**MINUTES
WORCESTER TOWNSHIP PLANNING COMMISSION
WORCESTER TOWNSHIP COMMUNITY HALL
1031 VALLEY FORGE ROAD, WORCESTER, PA 19490
THURSDAY, MARCH 28, 2024 - 7:00 PM**

Re: White Tail Farm, LLC – 1543 N. Trooper Road – Lot Line Relocation
CKS Reference: 7201-173

Reference: 1035 Trooper Road
Parcel No. 67-00-01540-004
"Trooper Ridge" Sketch Plan Review

Re: MCPC #24-0066-001
Plan Name: 1035 Trooper Road
(2 lots comprising 15.11 acres)
Situate: Trooper Road and Germantown Pike
Worcester Township

LOT LINE RELOCATION PLAN
 WHITE TAIL FARM LLC
 WORCESTER TOWNSHIP
 MONTGOMERY COUNTY
 PENNSYLVANIA
 PREPARED FOR
 WHITE TAIL FARM LLC
 1815 GALLAGHER ROAD
 PLYMOUTH MEETING, PA 19462

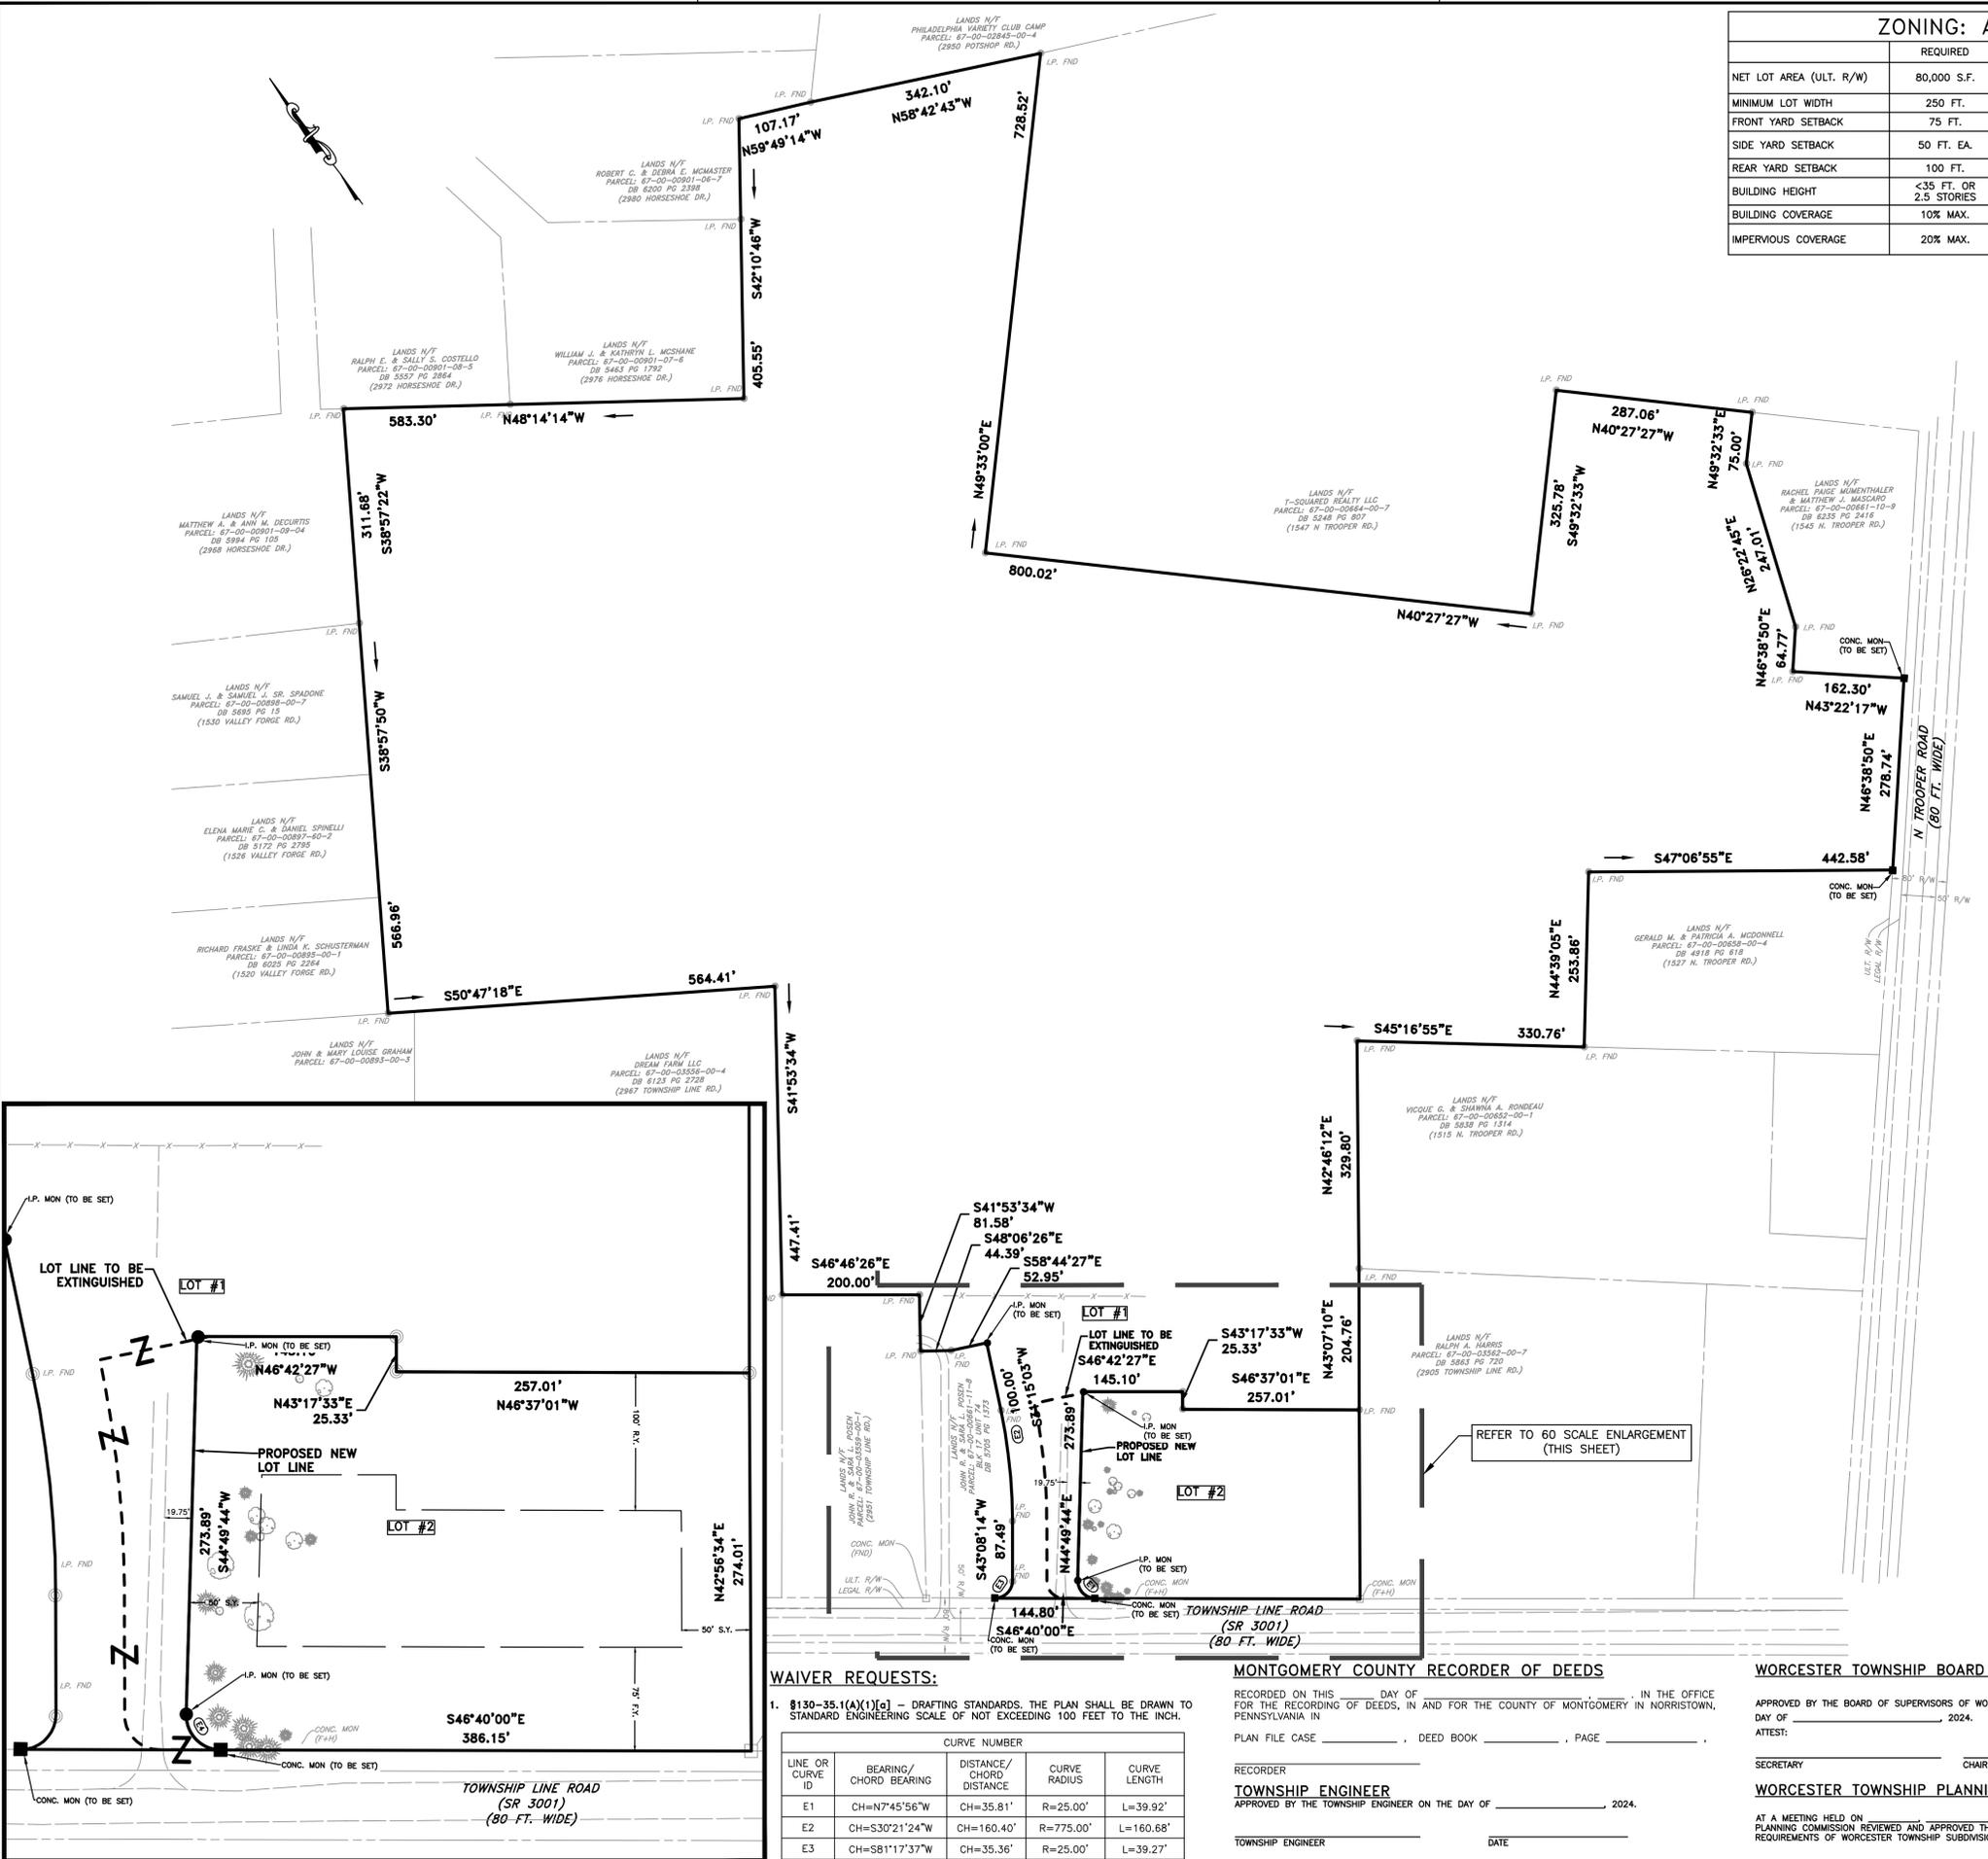
- a) *The plan shall be drawn at a scale not to exceed 100 feet to the inch. A waiver from this requirement has been noted on Sheet 3 and requested in a letter to the Township dated February 2, 2024.*

RESPONSE: acknowledged.

**TROOPER RIDGE
 SKETCH PLAN EXHIBIT**

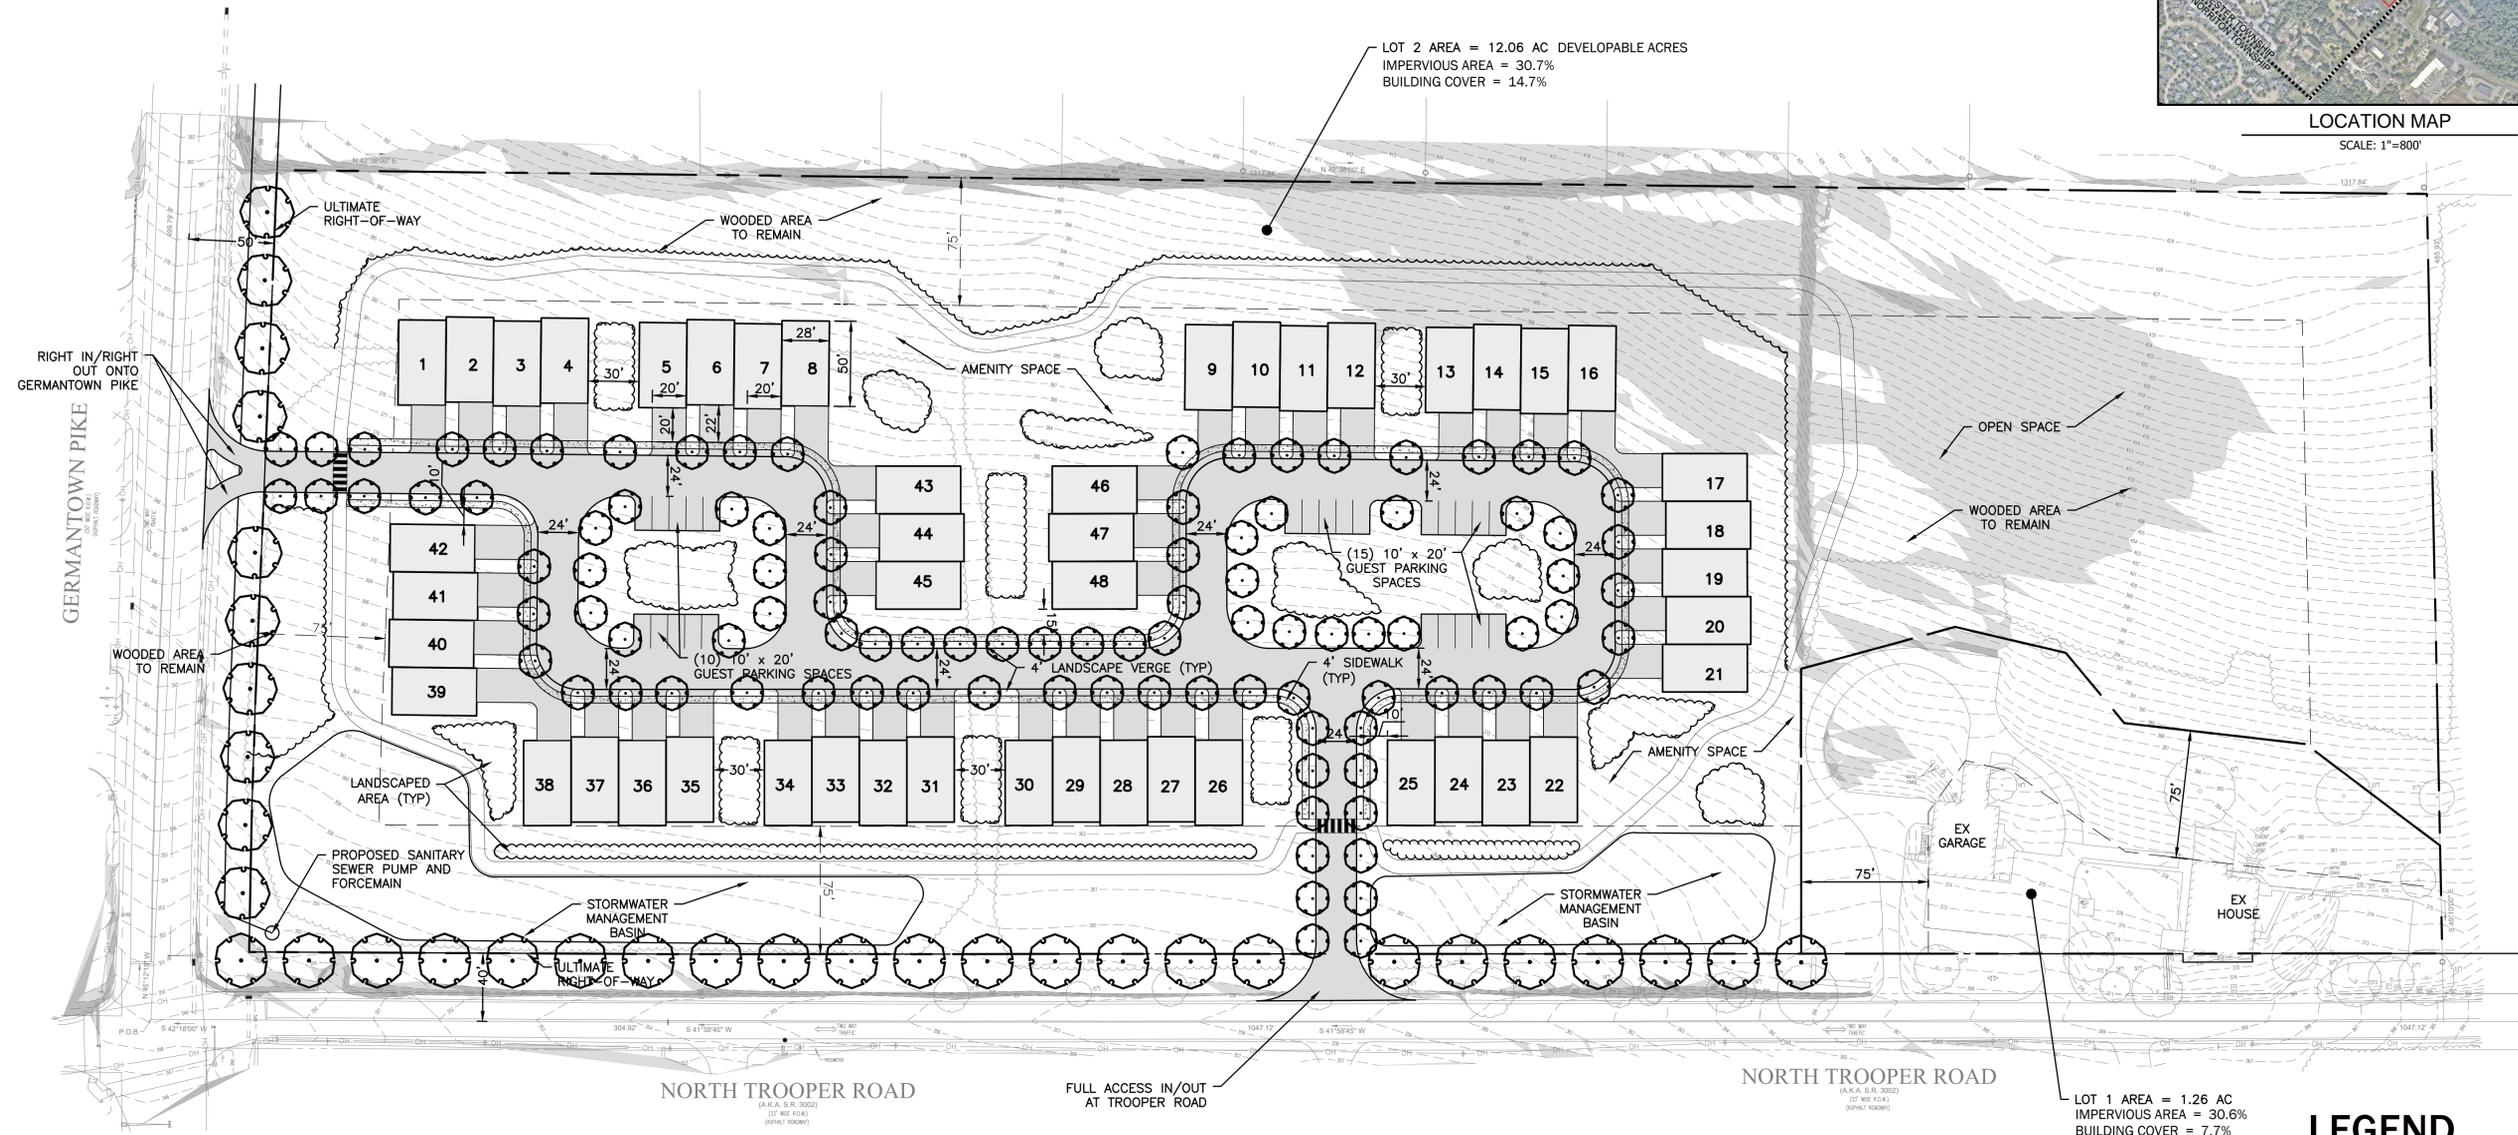
1. Ordinance No. 285 adopted June 16, 2021 made the MR Multi-Residential Overlay District applicable to this property with underlying zoning districts to remain. The existing 15.11-acre lot consists of two zoning districts, approximately 21% C-Commercial and 79% R-100 Residential. Once subdivided, Lot 1 will be entirely R-100 and Lot 2 will be approximately 19% C-Commercial with the remainder being zoned R-100 Residential. For clarity, the applicant should define the zoning district boundary on future plan submissions.

3. The proposed use of Lot 2, multi-family dwellings consisting of 48 townhouses, is permitted in the Multi-Residential District at a density of four units per developable acre. The plan notes a lot area of 12.06 acres; therefore, 48 townhouses is a permissible density only once the applicant provides a calculation demonstrating how the lot area was determined. The density may need to be reduced if the calculation returns a lesser lot area. (150-83.B and 150-89.E.1)

4. The applicant should confirm if the townhouses will be slab on grade or provide basements. All townhouses are limited to two stories and thirty feet in height. Due to the existing slope of the site, some units may have walk-out basements that could qualify as stories.

8. The plans show the conceptual stormwater management basins located in front yard setbacks. For multi-family residential districts, no part of any detention basin shall occupy more than 35% of the required yard area of any district yard. Additionally, no detention basin shall be located closer to any building containing two or more multi-family dwelling units than the minimum distance required between buildings. We note that a required 30-ft. separation is required between the stormwater facility and the townhomes. (150-89.D and 150-203)

9. No part of any detention basin shall be located 25 feet from any property line. (150-203)
10. The 75-foot unbuilt upon buffer strip between Lots 1 and 2 is not achieved in the vicinity of units 19 through 21. A variance will be required to place these units as currently shown on the sketch plan. Additionally, where homebuyers opt for a 10-foot patio or deck, this installation as described in Plan Note 1, will be an encroachment of the 75-foot buffer yard requirement at numerous locations throughout Lot 2. (150-89.E.6.a)

12. The required 130-foot sight triangle appears to be partially encroached by plantings. Clear sight triangles will need to be illustrated at intersections with Germantown Pike and Trooper Road on future submissions. (150-89.E.6.b.4)

ATTACHMENT B: SITE PLAN

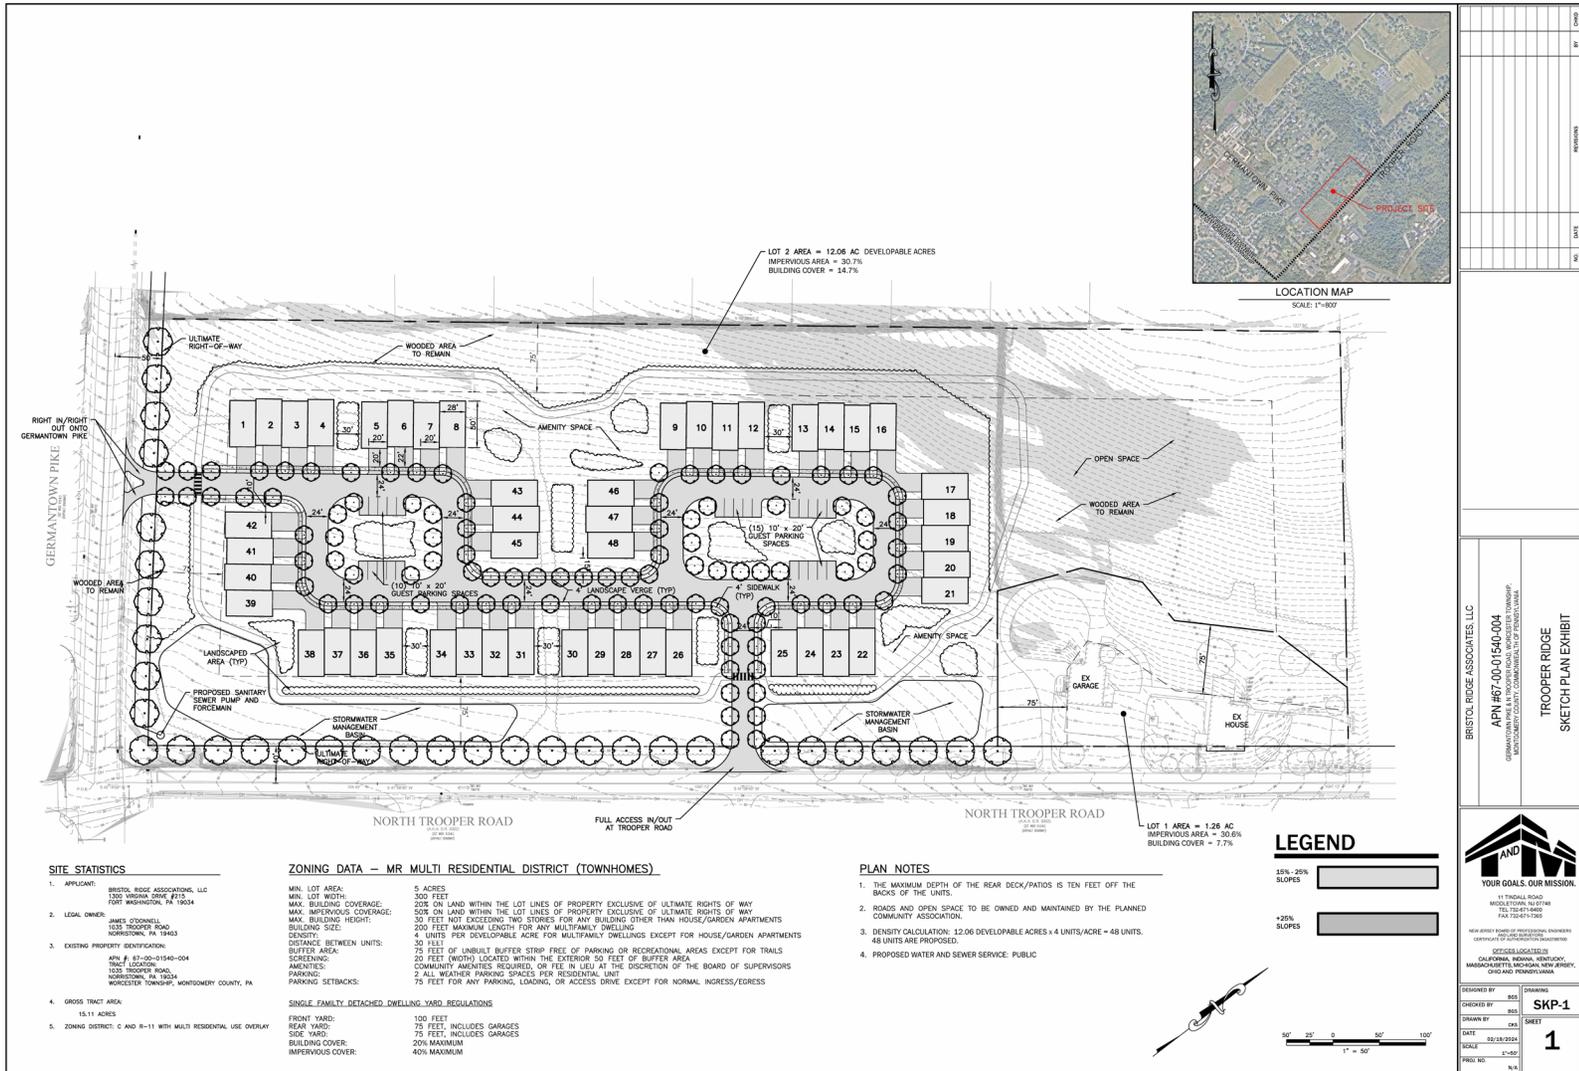
1. Front Yards. As proposed, with 20-foot-wide driveways and 28-foot-wide townhouse units, the front yards of the townhome units only measure 8 feet wide, and contain no sidewalk connections to the units. The Applicant may want to consider pairing adjacent garages and driveways to closely abut, which will consolidate green spaces and provide better planting areas.

2. Street Trees. We appreciate the Applicant's proposal to plant a significant amount of street trees, both along Germantown Pike and Trooper Road, as well as within the development itself. However, at present the configuration of the sidewalks, the green verge areas between the sidewalk and street, and possible underground utility lines will reduce the viability of these trees. The Applicant should consider setting the sidewalk further back from the street (which may result in setting back the townhomes a few feet to compensate) to make the green verge wider, the increased area of which will support more robust and lasting tree growth. As an alternative, the Applicant may consider placing the proposed trees behind the sidewalk and on the front yard areas of the townhome units.

4. Amenity Spaces. As a requirement of the MR District, the Applicant is required to place Amenity Spaces within the development; two spaces have been indicated on the plan. However, at present, they have not been further elaborated upon. Due to the density of the development, we would recommend at least one of the Amenity Spaces to include a Tot Lot. Other elements of equal substance should be considered, such as gazebos, pavilions and benches.

1. Trail Connections. At present, the trail is proposed to encircle the development in a loop. However, there are no direct connections indicated either into the development or to connections or destinations outside the project. We recommend the trail connect to the intersection of Germantown Pike and Trooper Road, where the County is planning to install ADA curb ramps. Additionally, we recommend the trail make connections *within* the development as well, not just where the trail intersects and crosses the two main access points of the development from Germantown Pike and Trooper Roads; particular attention should be paid to those units at the center of the development and at the northwest edge of the proposed neighborhood.
